9/12/2000
John Lohmeyer
T10 Chairman

Subject: Proposal for revised setup and hold figures to be included in SPI-4

Figure 42 - LVD timing measurement points for DT \leq **Fast-80** data transfers

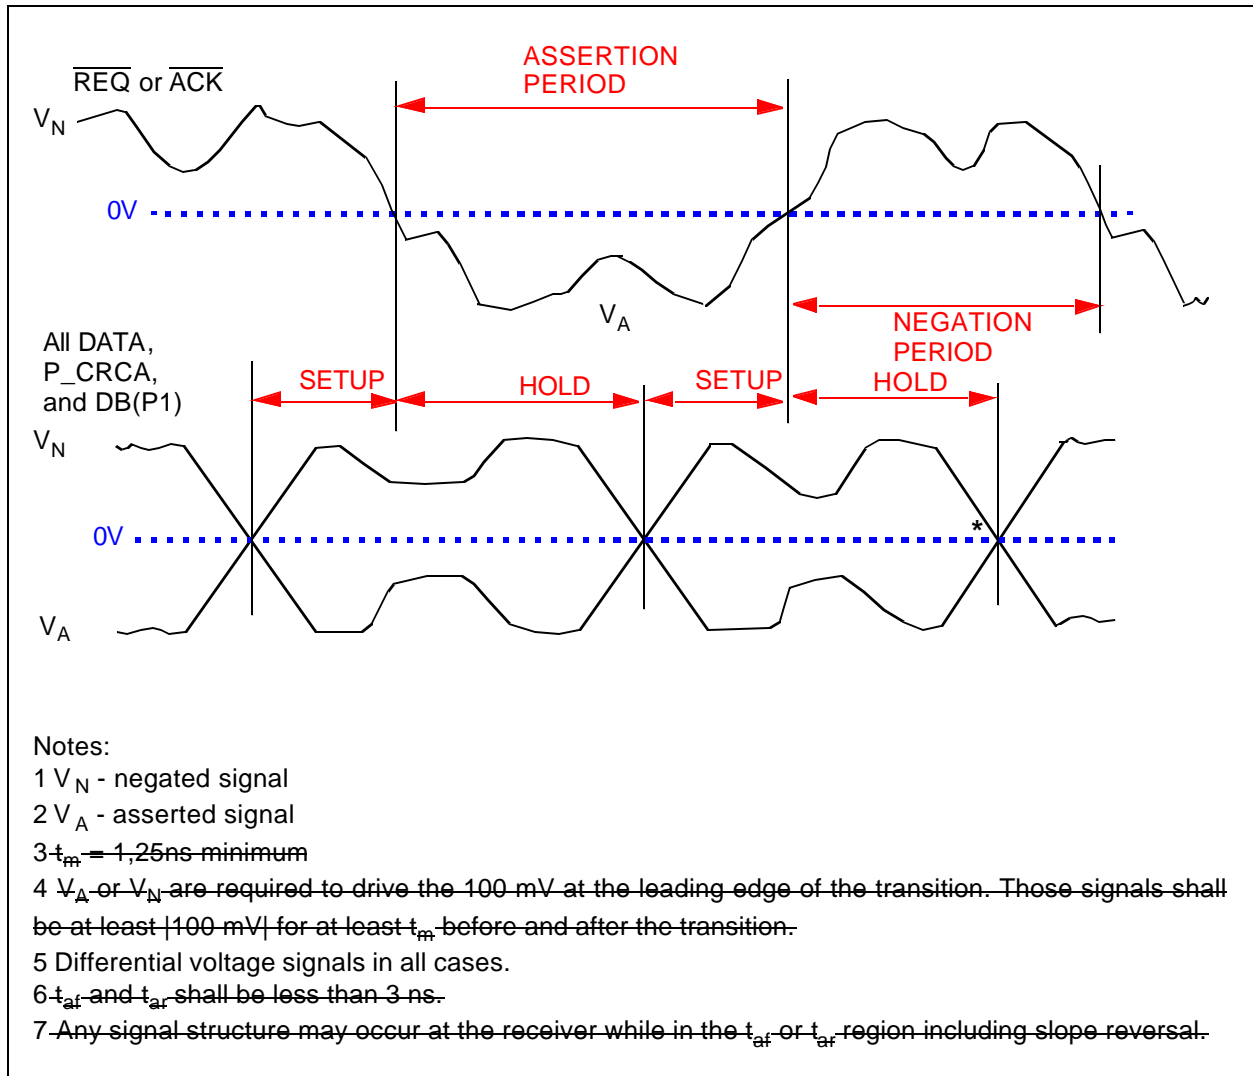
The attached figures have been described and I think agreed to in various working groups as word pictures. This proposal documents the word pictures in FrameMaker.

The signal shall transition from -100 to +100 mV or +100 to -100 mV in 0 to 3 ns, the waveform between -100 and +100 mV is not otherwise specified. Signals shall remain above the |100 mV| level for 1,25 ns at each end of the transition. The signals shall not drop below |30 mV| except during the transitions. Conditions exist with longer, loaded SCSI busses and irregular REQ and ACK pulse widths where long assertions or negations produce a much larger signal than short assertions or negations. This sets up an environment where the short REQ or ACK pulses may not have adequate timing margin unless the definitions in figure 44 are used in the measurement of timing parameters. If the P_EN bit equals one precompensation mitigates the charging effect and helps timing margin.

Figure 43 - LVD timing measurement points for DT = Fast - 160 data transfers

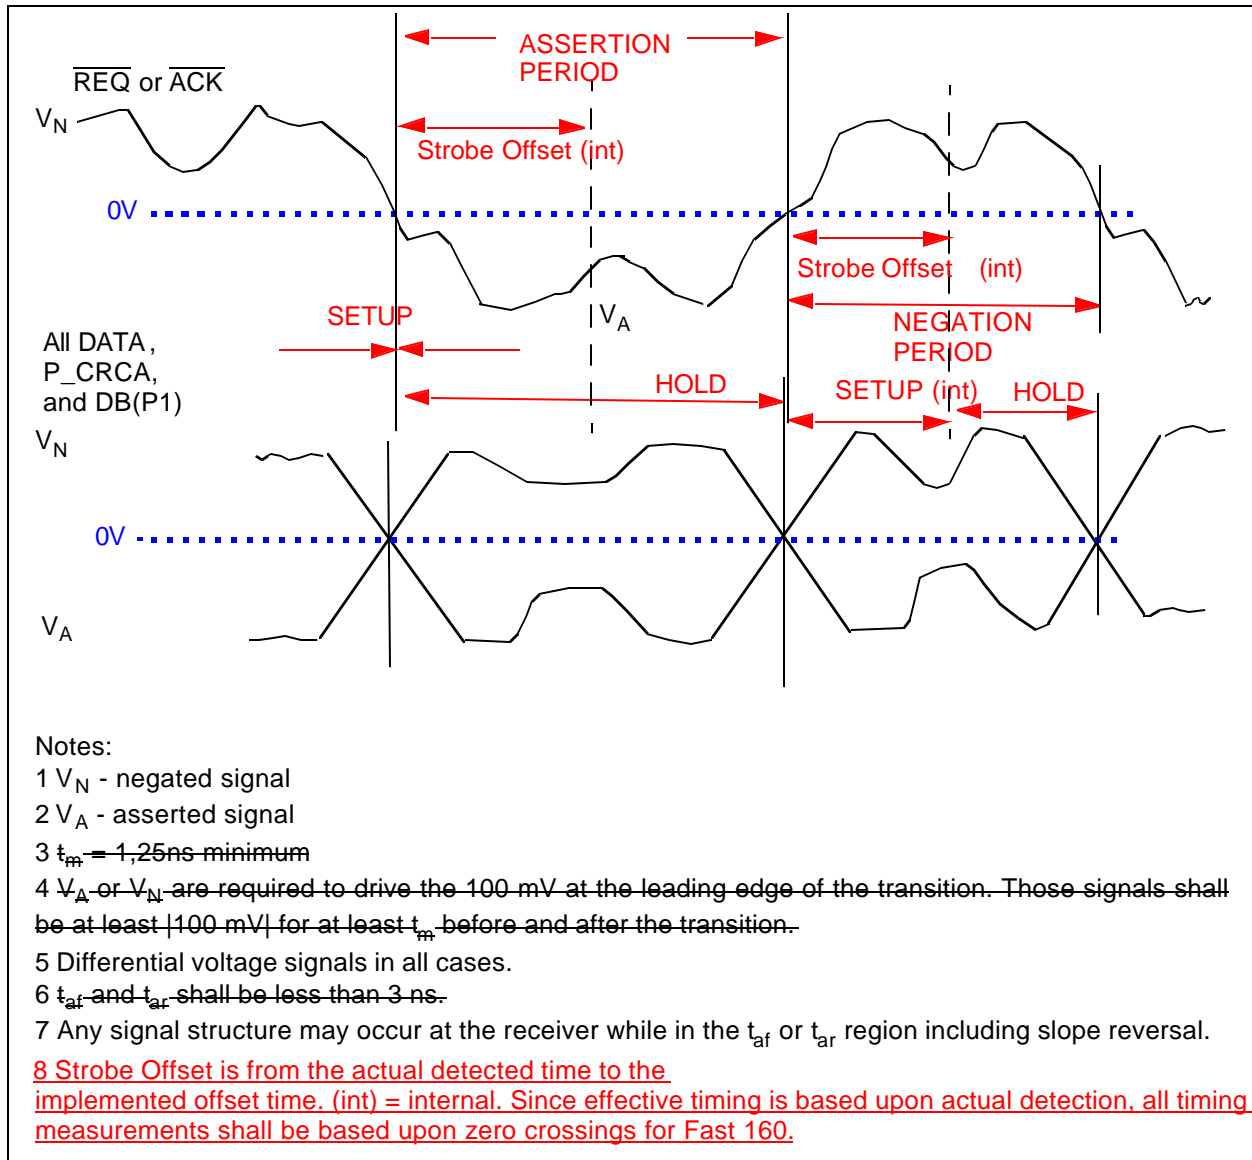
Measurement of driver timing parameters shall be performed using the circuit and test conditions defined in A.2.5 applied to the SCSI device connector. Receiver timing parameters are defined by the waveforms existing at the connector of the receiving SCSI device. The receiver timing parameters include the effects of data pattern. The receiver data pattern is therefore not defined.
